REMARKS

"Annotated Sheet Showing Changes"

Fig-1

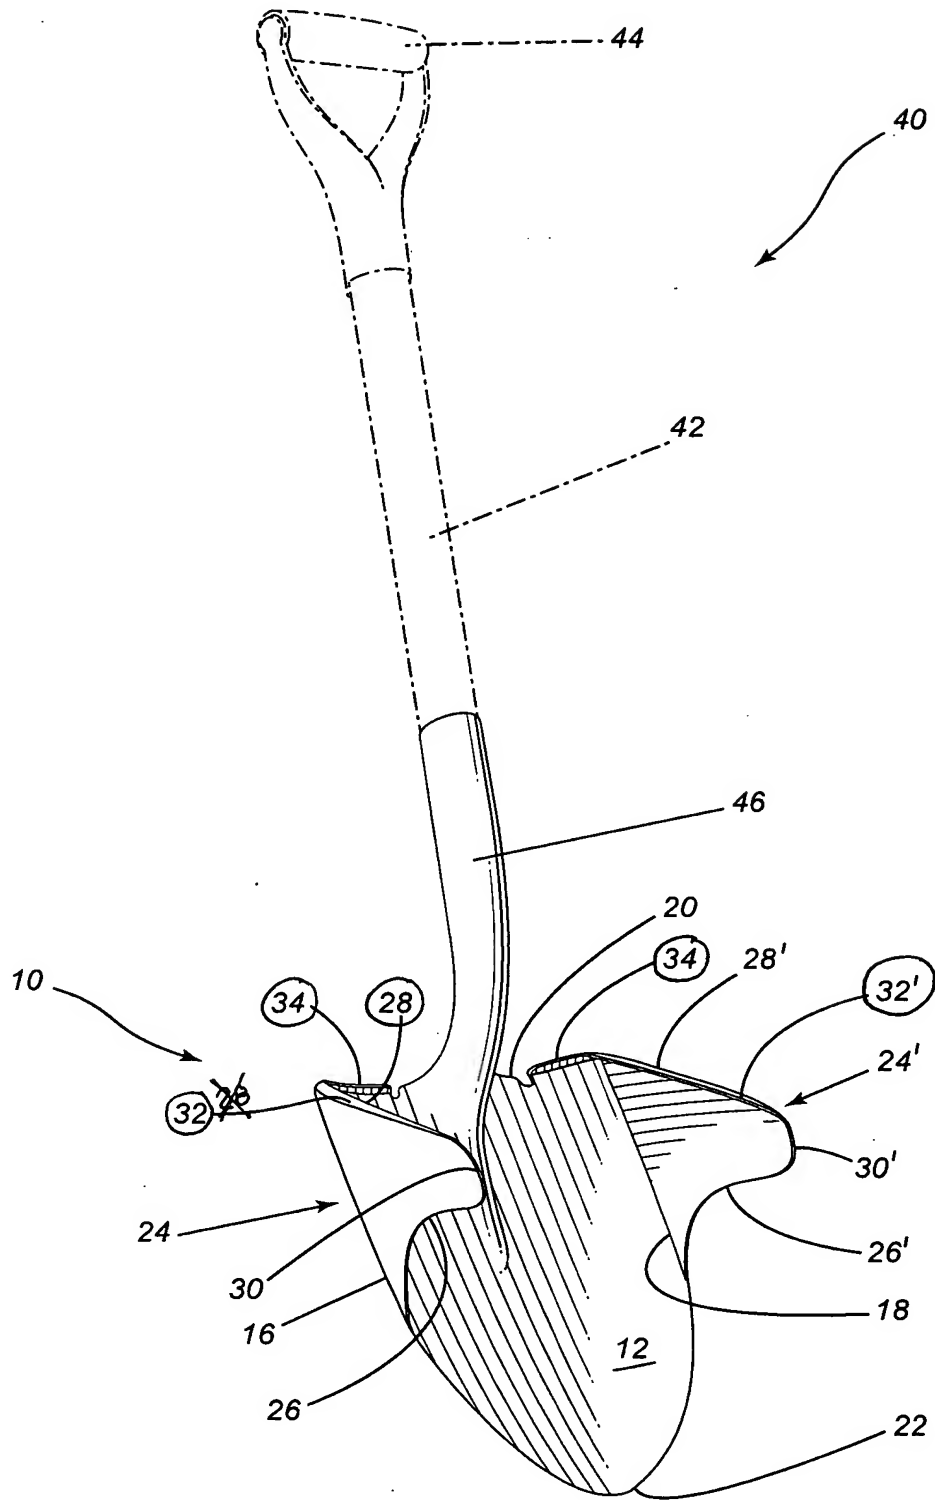
With this amendment, permission to amend the drawings is respectfully requested. In reviewing the drawings, it was noted that reference numeral 32 and 34 were absent and accordingly, these reference numerals have now been added to the application.
